# Access Compliance Report

## Public Rights-of-Way

| Intersection ID: 51181                  | Main Street: FIRCREST_DR | Cross Street: WHIPPET_RIDGE_CT          | Location: SE           |
| ADA ID: 72ED5DB39D8A                    | Ramp Type: PerpDiag      | Initial Pass/Fail: Fail                 | Overall Compliance: No |

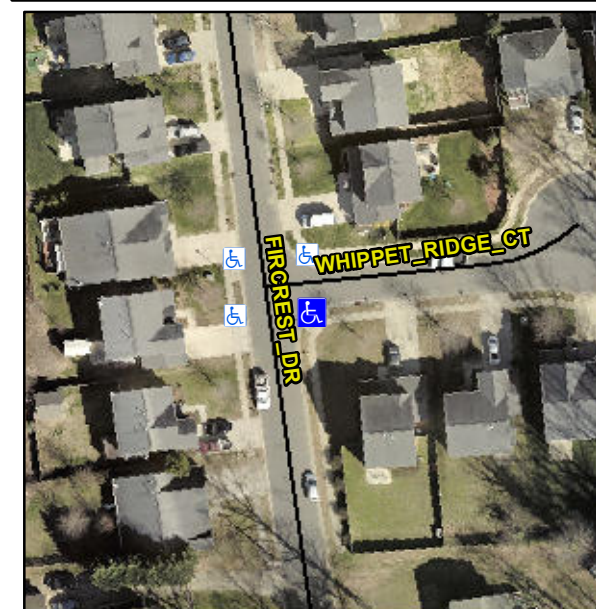
Surveyor Notes:

**N/A**

| Compliance | Description           | Data | Compliance | Description                 | Data |
|------------|-----------------------|------|------------|-----------------------------|------|
| No         | Ramp Width (in)       | 45.0 | Yes        | Ramp XSlope (%)             | 0.1  |

**Remove & Replace Curb Ramp With Two New Directional Ramps or Equivalent.**

**R304.5.1**
